National Committee on Uniform Traffic Control Devices

National Committee on Uniform Traffic Control Devices (NCUTCD) Recommended Changes to Proposed Text for 11th Edition of the MUTCD Docket Number: FHWA-2020-0001

- 1 **Federal Register Item Number:** 185 to 227, 647
2 **NPA MUTCD Section Number:** 2E.01 to 2E.59, Appendix A1
3 **Legend:** Base text shown in proposal is the NPA “clean” proposed text.
4 • [NCUTCD recommendation for text to be added in final rule.](#)
5 • [NCUTCD recommendation for text to be deleted in final rule.](#)
6 • [NCUTCD recommendation for text to be moved/relocated in final rule.](#)
7 • [NPA text that was not previously approved by NCUTCD but is now approved.](#)
8 • Explanatory note: [Note that explains purpose of recommended change.]

Figure 2E-61. Example of Weigh Station Signing on Freeways

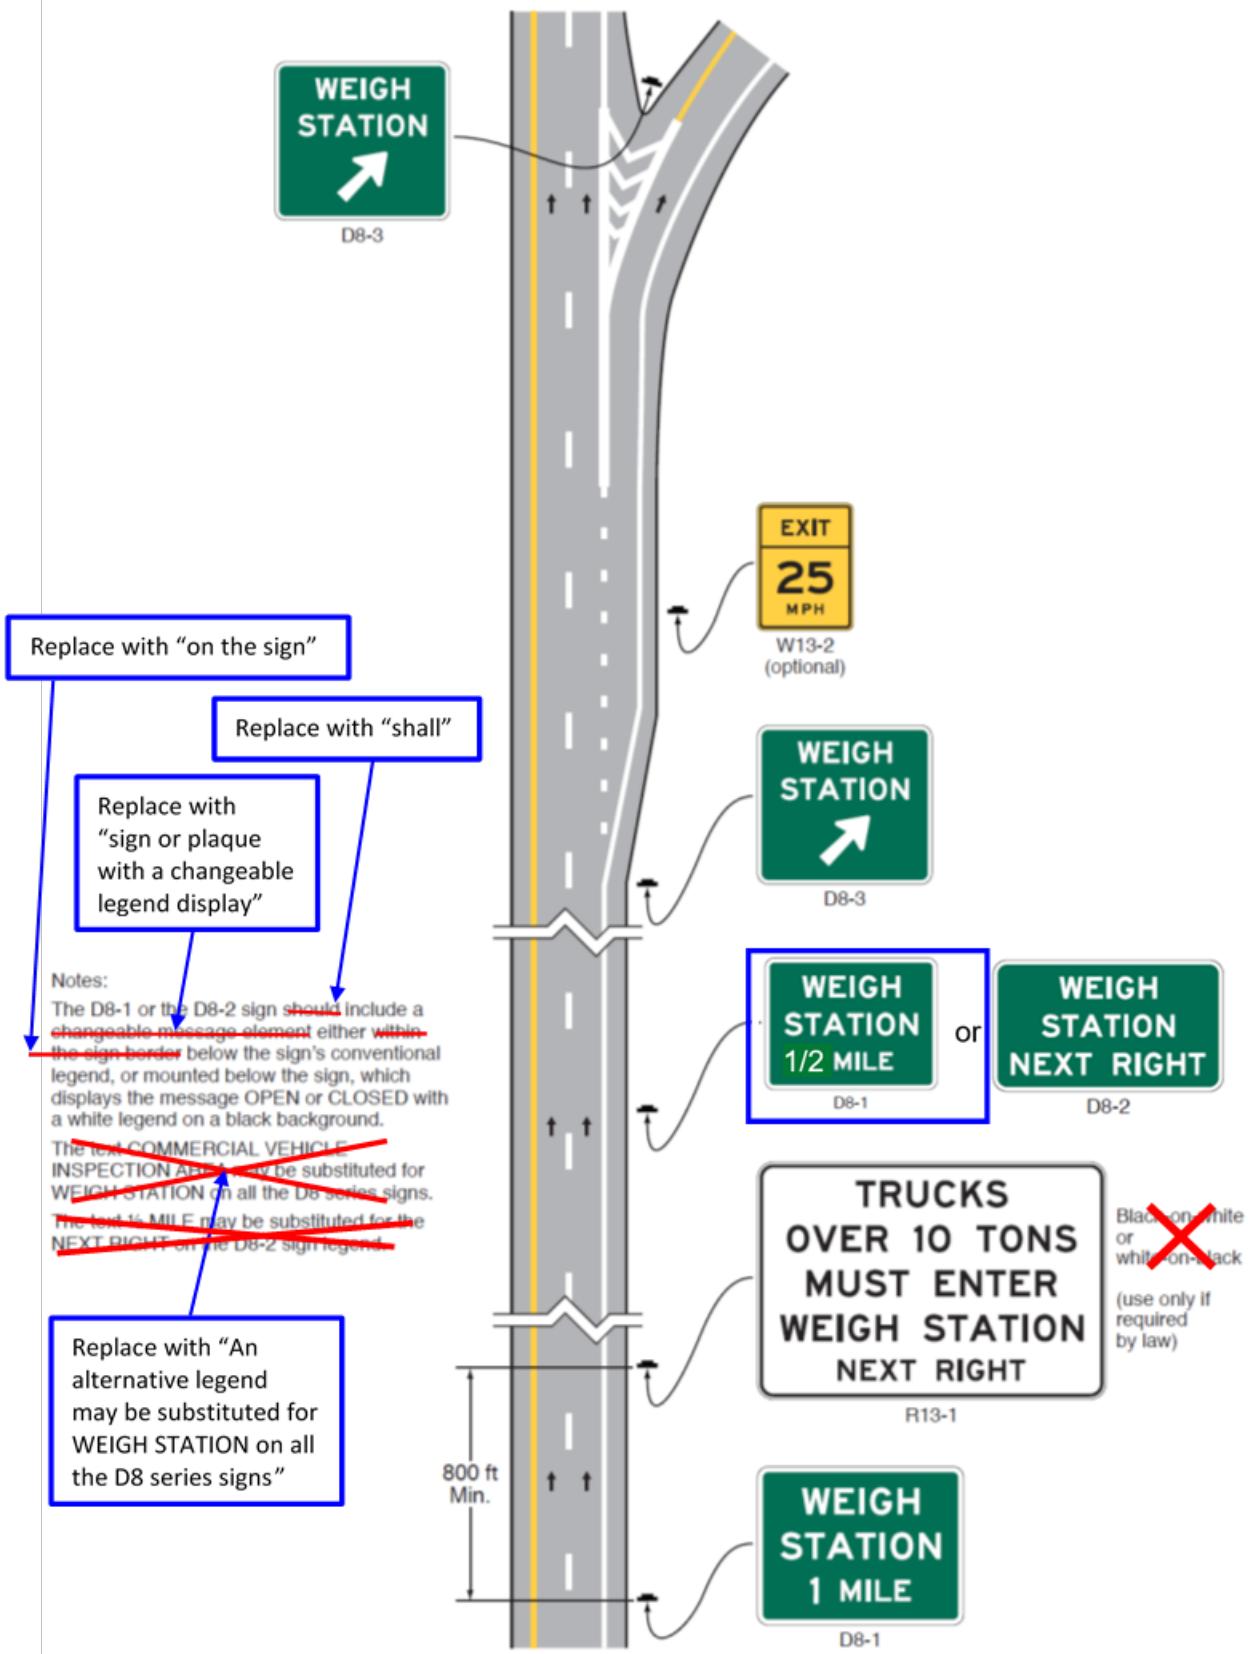
- 3173 • Add a D8-1 with ½ MILE distance next to the D8-2 as an acceptable alternate
- 3174 • Delete the note adjacent to the R13-1 sign that allows white on black to be consistent with
3175 Section 2B.67
- 3176 • Revise the first note as follows:
 - 3177 ○ Delete the words “within the sign border” and replace with “on the sign”
 - 3178 ○ Revise the word “should” to “shall” to conform with the text
 - 3179 ○ Revise “changeable message element” to “sign or plaque with a changeable
3180 legend display” to conform with the text
- 3181 • Revise the second note to read “An alternative legend may be substituted for WEIGH
3182 STATION on all the D8 series signs”
- 3183 • Delete the final note
